Project	IEEE 802.16 Broadband Wireless Access Working Group < http://ieee802.org/16 >	
Title	Consideration of technical issues to support WG Letter Ballot 13 comments against the consolidated IEEE 802.16 draft, P802.16-REVd/D1.	
Date Submitted	2003-10-31	
Source(s)	Barry Lewis, Paul Piggin and Philip Whitehead Radiant Networks PLC The Mansion, Chesterford Park Little Chesterford, Essex, CB10 1XL, UK	Voice: +44 1799 533600 Fax: +44 1799 533601 barry.lewis@radiantnetworks.co.uk
Re:	Comment resolution following WG Letter Ballot #13 on P802.16-REVd/D1 during WG Session#28.	
Abstract	This document contains supplementary technical information to support comments proposing enhancements to the consolidated IEEE 802.16 draft, which will produce a more comprehensive multipoint system standard. No new modes that are not already described in the standards are required. Nothing is deleted from existing standards. These proposals have been defined in detail and analyzed against the existing draft.

Consideration of technical issues to support WG Letter Ballot 13 comments against the consolidated IEEE 802.16 draft, P802.16-REVd/D1.

Paul Piggin, Barry Lewis, Phil Whitehead – Radiant Networks

Figure 3 Representation of the management of the FCH across supported links.

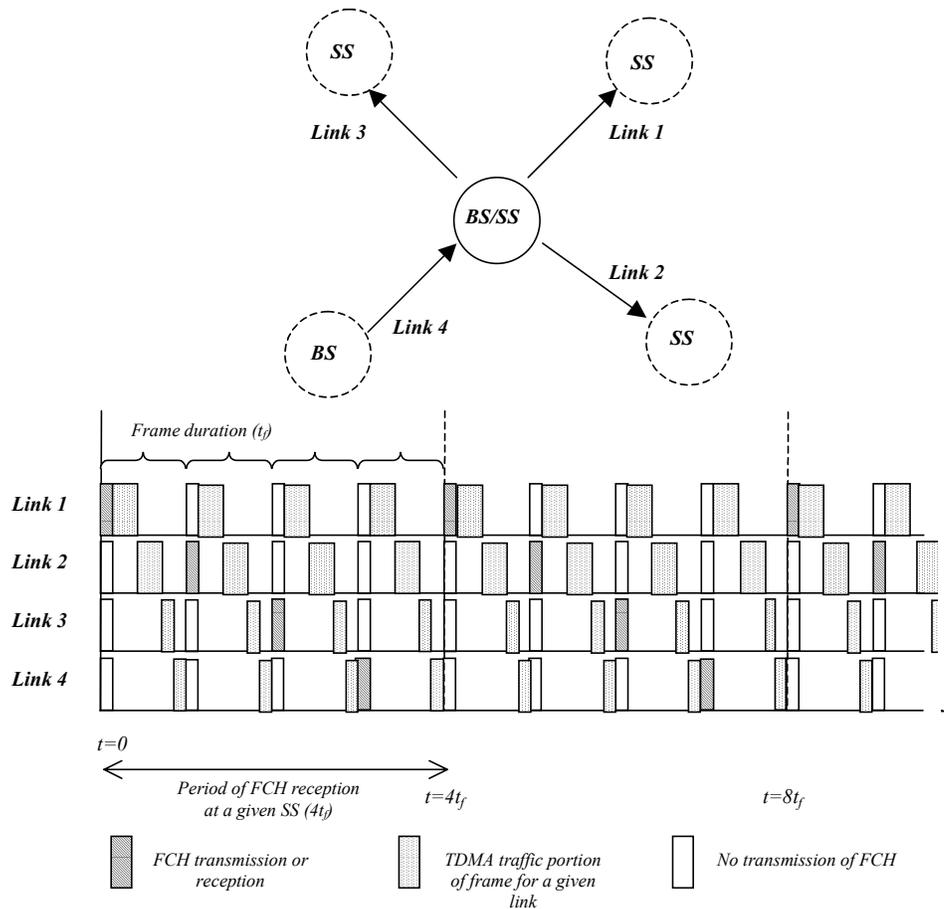
This solution transmits frames simultaneously on the number of links supported making decisions on which link receives the preamble and FCH. Traffic bursts are transmitted across all links during the frame. Issues with this approach are related to the retention of synchronisation. Synchronisation is to be enhanced via a TDMA preamble for data bursts. A diagrammatic representation of this concept is given in Figure 3. This representation shows a node behaving as a BS and SS. The BS controls 3 SS entities at other nodes, with an SS being

supported via *link 4* in the diagram. During a frame the FCH is directed at a particular link with the remainder of the frame providing data bursts across the links supported.

Currently, a PMP SS would expect to receive the FCH every frame, although there is a mechanism for retrying if it is not received. However DM SSs need to be configured to expect the FCH to be present only a percentage of the time. If the DL-MAP is used to describe sufficiently far into the future, then a SS can retain synchronization. It is likely that both the SS and the node acting as a BS will be required to accommodate more timing (and therefore frequency) uncertainty than in a PMP system that will receive the FCH every frame.

- FCH is directed so the SS sees it 1 out of n times.
- The set of values for the PHY synchronisation field in the DL-MAP is expanded to indicate DM vs. PMP.
- The DL-MAP and UL-MAP are allowed to define when the FCH is to be again received.
- The nodes would need to be more tolerant of timing errors; hence support for TDMA in the downlink is configured.

Figure 11 Illustrative use of the DL-FPC MAC message.

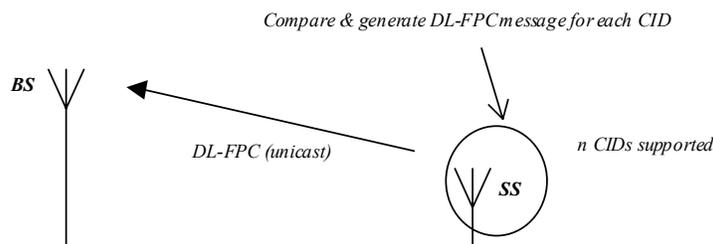
A DL-FPC MAC message is provided for optional downlink FPC. This message is generated by the SS in response to a decision made by a downlink power control algorithm implemented in the SS. This is illustrated in Figure 11. The power control algorithm is outside the scope of the standard but is likely to be based on the assessment and tracking of CINR. Each SS sends a DL-FPC MAC message using the basic CID. This controls the transmit power of the TDMA data burst for the paired CID at the BS. The SS is able to make independent power control decisions for all CIDs it supports in the downlink. In this way a specific SS may be power controlling a number of TDMA bursts with distinct CIDs. Power control of the FCH via the DL-FPC MAC message is a special case where a specific CID transmitted by the SS is recognised by the BS and used to change the power of the FCH transmission.

For DM operation, it is likely that a single SS may support several CIDs. Each CID is supporting a single data burst within the frame structure and will require individual power control. This is due to the fact that not all data bursts will be on the same frequency. Alternatively, multiple messages (with different CIDs) targeted for the same SS would be aggregated into a single burst that would be identified by basic CID in the DL-MAP. Power control could be asserted on these entities, not individual messages. Realisation of the DL-FPC MAC message is given in Figure 12. The BS handles the control of power in the downlink for each burst. From mapping of the CID received in the DL-FPC MAC message the BS can change the transmit power for a particular burst keyed by the CID.

Figure 17 *Implementation of uplink power control.*

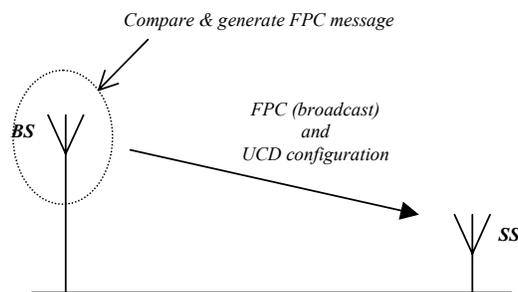
It is possible to use a more efficient means of encoding power control information in the downlink to provide uplink power control. Using a 4 bit code to represent the difference between the last power control measurement and the current one is more efficient than explicitly sending the 8 bit power level change. Given that potentially there are many SS to support, the use of a 4 bit code rather than an 8 bit representation of the value can provide a significant capacity saving due to a reduce MAC message size. The use of the 4 bit *Power Control Difference Code* is illustrated in Figure 15 and can be added after . This provides for a range of power control values from the configuration of a single value, termed the *Power Control Difference Base Value*. This change is proposed to all PHYs.

An example is shown in Figure 17, with the modified FPC MAC message shown in Figure 18.
